Subject: FW: Grenfell Tower, Grenfell Road, Refurbishment - Fire Strategy P2

Grenfell Tower, Grenfell Road, London. W11

Subject: Grenfell Tower, Grenfell Road, Refurbishment - Fire Strategy P2

Subject: Grenfell Tower - Smoke exhaust LFB submission.

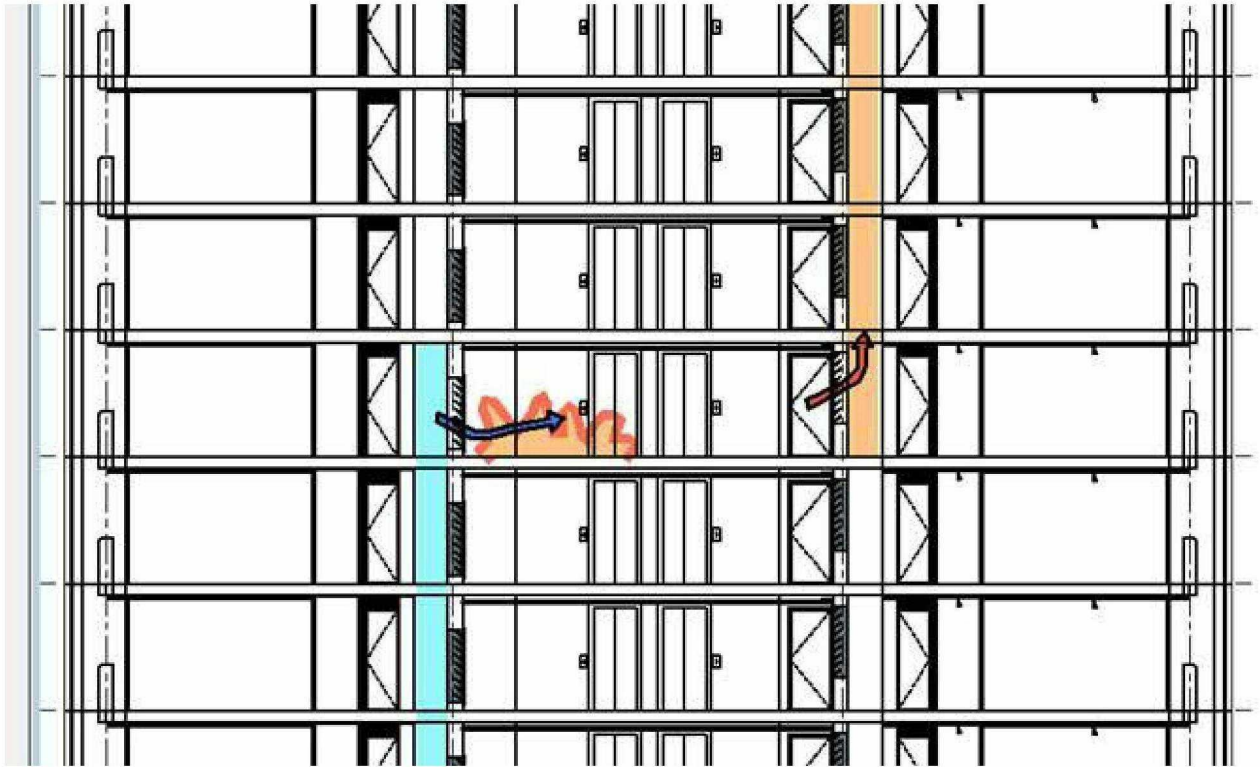
1. "...is designed .. as a natural ventilation system..." (line 2) is followed by "a mechanical supply and extract system which does not rely on natural ventilation" (Smoke Control, second para). His initial response is that this reads like we are omitting a compliant natural vent shaft. **We could just leave the 'compliant' system as it is at present, but we (and Exova) think it would be better to provide a more predictable system with mechanical supply and extract as the default mode, all as described in the 'Proposed System' part of our report.**
2. Some diagrams would be useful. **I have attached our schematic drawing and Studio E have provided the visual representation below.**

3. Principle of dual use of duct for vent and smoke okay – but not clear from document and would like some detail as to how this will be achieved.

The smoke controls and the temperature controls would all be part of the same control system controlling the dampers and the supply and extract fans.

Under normal conditions, all the dampers would be open and the system would operate as a natural ventilation system. Temperature sensors would be located on 'typical' (say 5 No.) lobbies. If the temperature in any of these areas exceeded a pre-set comfort level, then the supply and extract fans would operate to try to reduce the temperature.

In the event of smoke being detected within any lift lobby served by the smoke control system, the fresh air and smoke dampers serving that particular lobby would remain open and the supply and extract fans would operate. The fresh air and smoke dampers on all other levels would be closed. The system would be set up such that it was 'fail-safe' with priority always being given to the fire safety operation.
